VILLAGE BOARD AGENDA

ITEM DESCRIPTION: Site & Architectural Review – Footworks Dance Company 103/109 W Kimberly Avenue
REPORT PREPARED BY: Sam Schroeder, Community Development Director
REPORT DATE: May 27, 2025
ADMINISTRATOR'S REVIEW / COMMENTS: <div style="margin-left: 40px;"> No additional comments to this report _____ See additional comments attached _____ STS _____ </div>
<p>EXPLANATION: Harris & Associates, Inc. on behalf of Footworks Dance Company by Kim LLC (Footworks) has submitted a site review application to construct a new dance studio at 103/109 W Kimberly Avenue. These lots are vacant and owned by the Village.</p> <p>The new building would be 60 feet by 110 feet for a total of 6,600 SF. The building would be located on the north half of the property with the front entrance along W Kimberly Avenue. A private parking lot totaling 12 parking stall will be located south of the building. Per the development agreement, the Village will also be building a public parking lot west of the alley. This lot would be roughly 16+/- stalls. Combined with on-site parking, the public parking lot and street parking, the area will have enough parking to support this development.</p> <p>T

LANDSCAPE PLAN

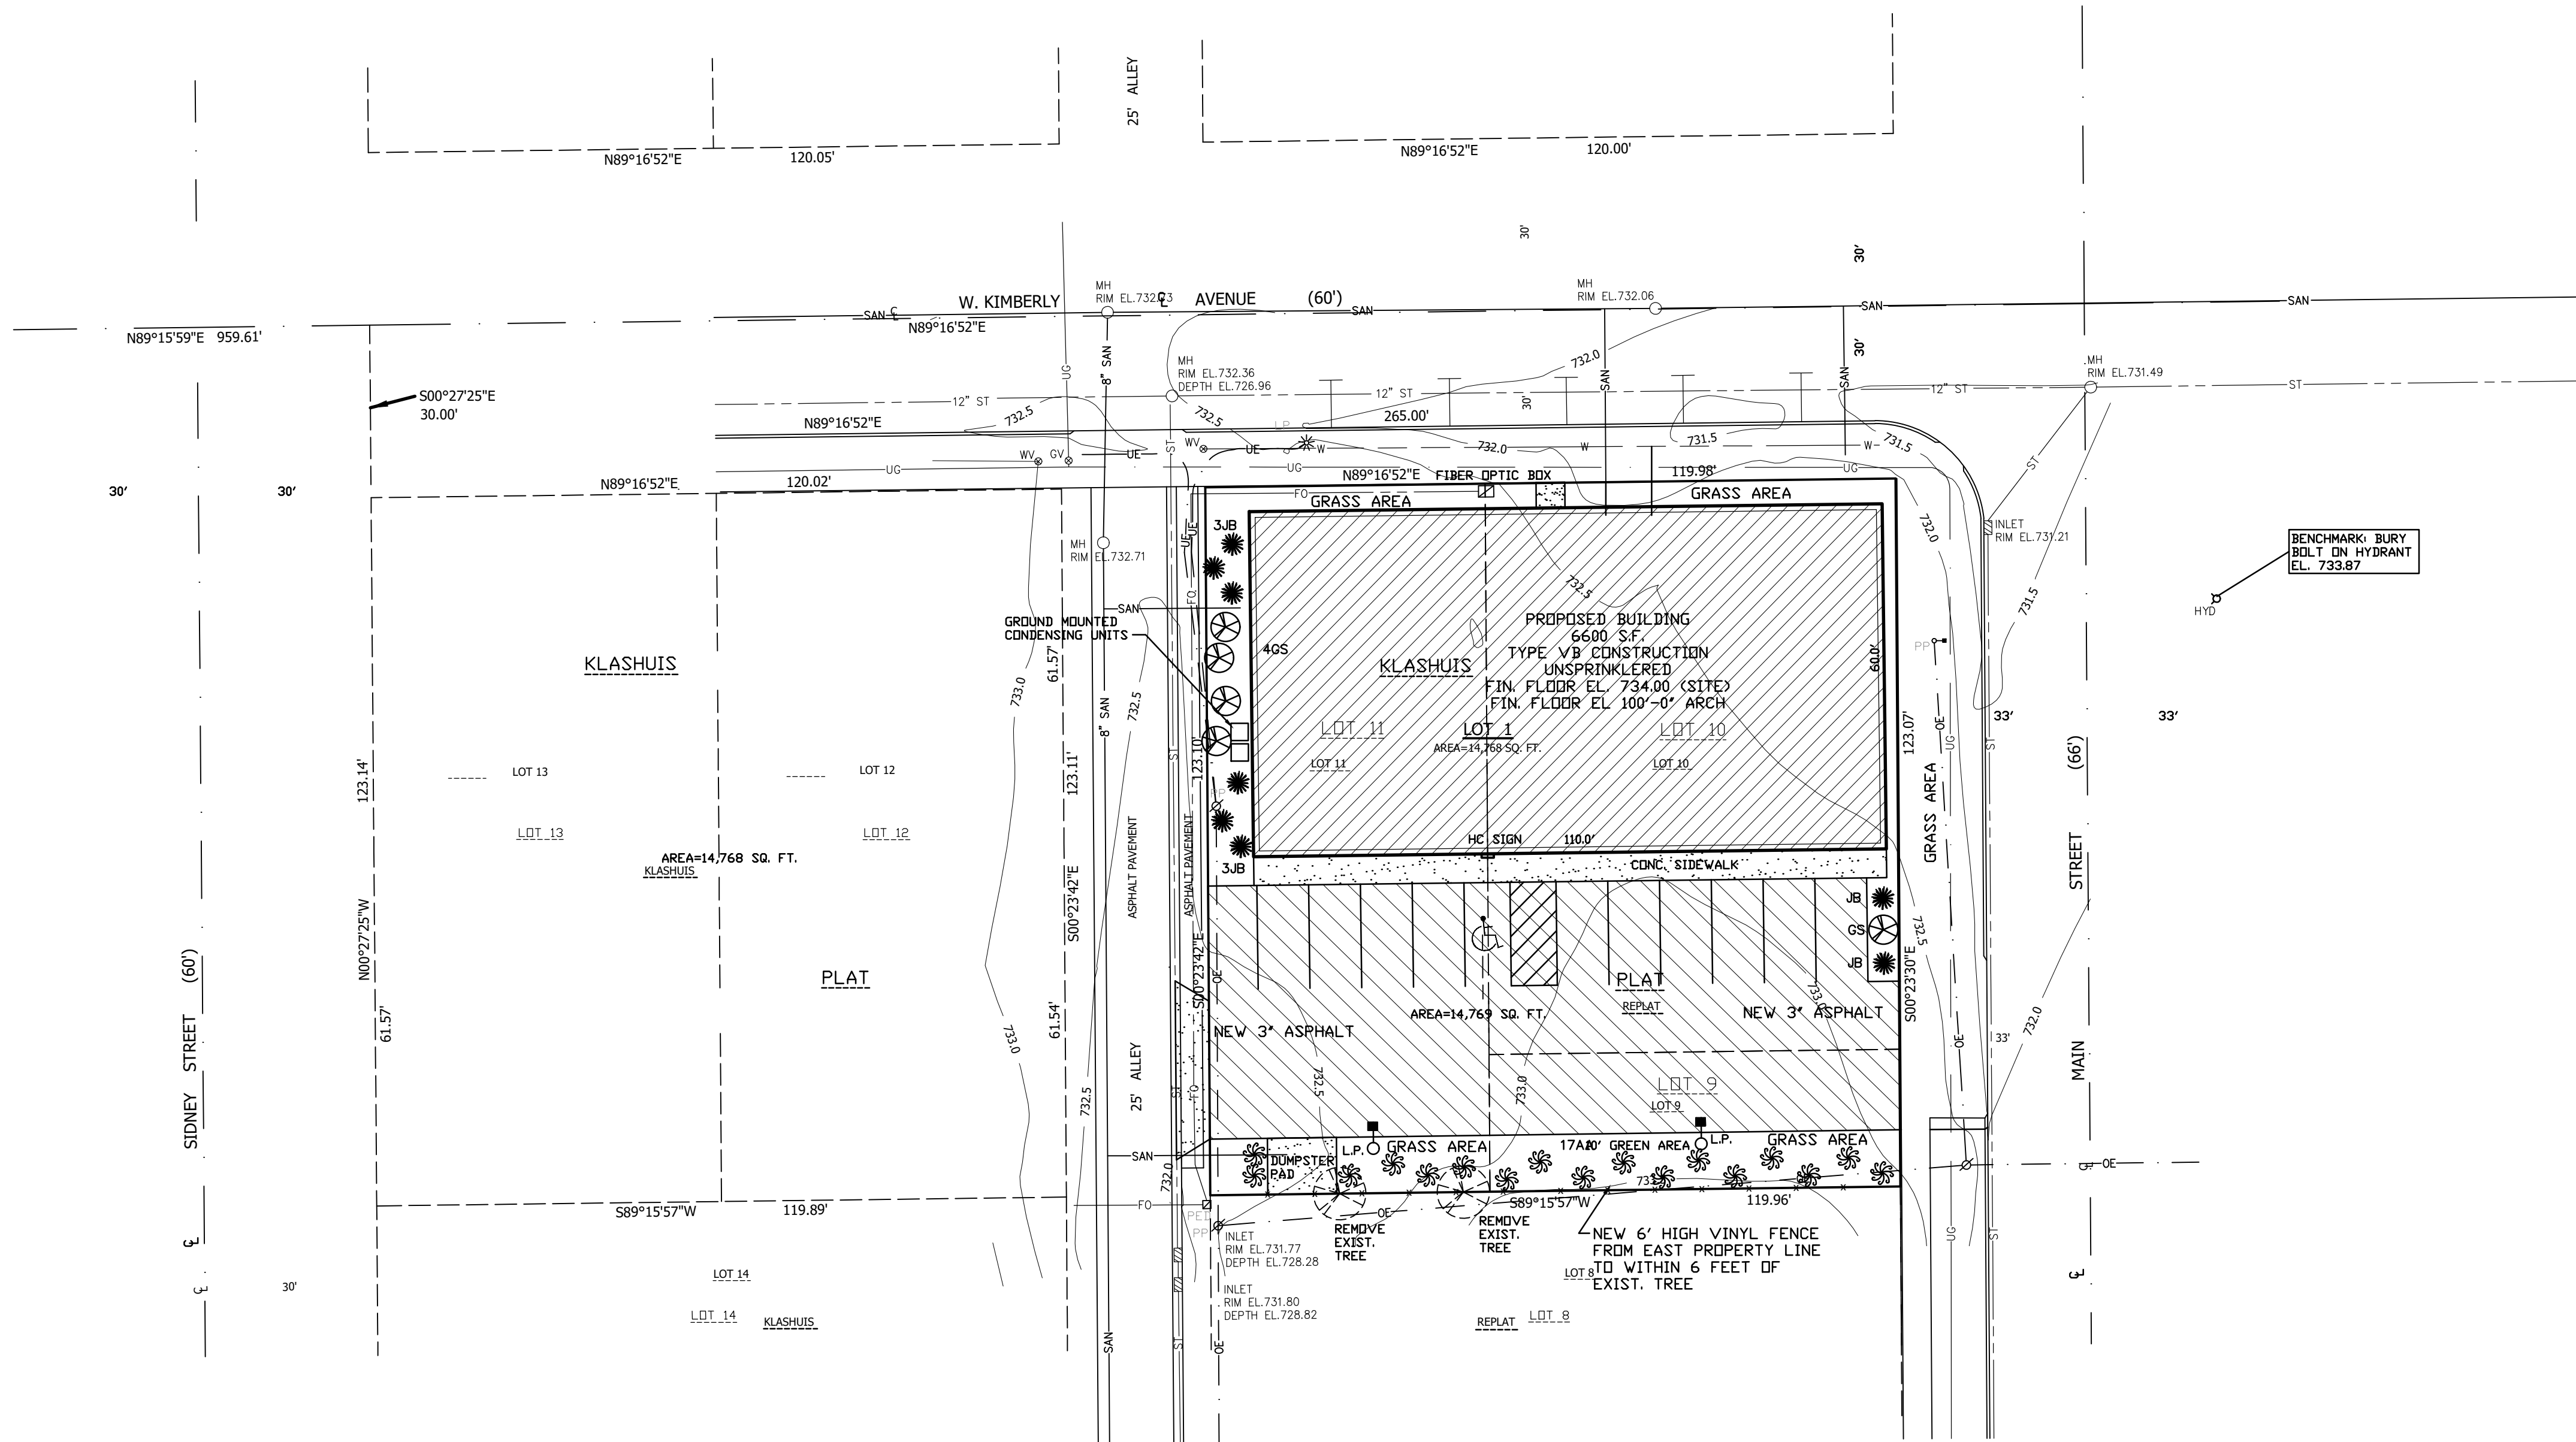
The site plan does indicate a 10 foot buffer area along the south side of the property abutting the single-family residential home. This area will be planted with arborvitae to create a large vegetative screen meeting the intent of the code.

3. **Residential Buffer.** Due to the proximity of the parking lot to the residential, staff is recommending a solid fence be added in addition to the proposed landscaping per code. In adding the initial planting height of the arborvitae shall be a minimum of 5 feet.

4. **Landscaping.** The applicant shall provide details of the ground cover material in the landscape areas. In addition, verification of the areas north and east of the building shall be determined. If space allows additional landscaping or planter boxes shall be provided in the front of the façade to break up the otherwise flat wall. In addition, the 3 foot paving strip that is currently located along the alley shall be removed and the green space be expanded to provide some buffer and delineation to the alley.

1. Additional façade elements shall be considered prior to the issuance of building permits to break up the long expansive walls and roof line.
2. All lighting shall be full cutoff unless it is less than 1,200 lumens and meets Village Ordinance.
3. A solid fence shall be provided within the buffer yard and the proposed landscape materials shall not be less than 5 feet tall at the time of install.
4. Additional landscaping or planter boxes shall be provided along the front of the building.
5. The 3 foot asphalt strip along the alley shall be removed and blended with the green space.
6. Grading of the site shall be verified to ensure no negative impacts to the surrounding residential development.
7. Any refuse beyond standard residential carts shall be screened from off-site view and be located in the rear of the building.
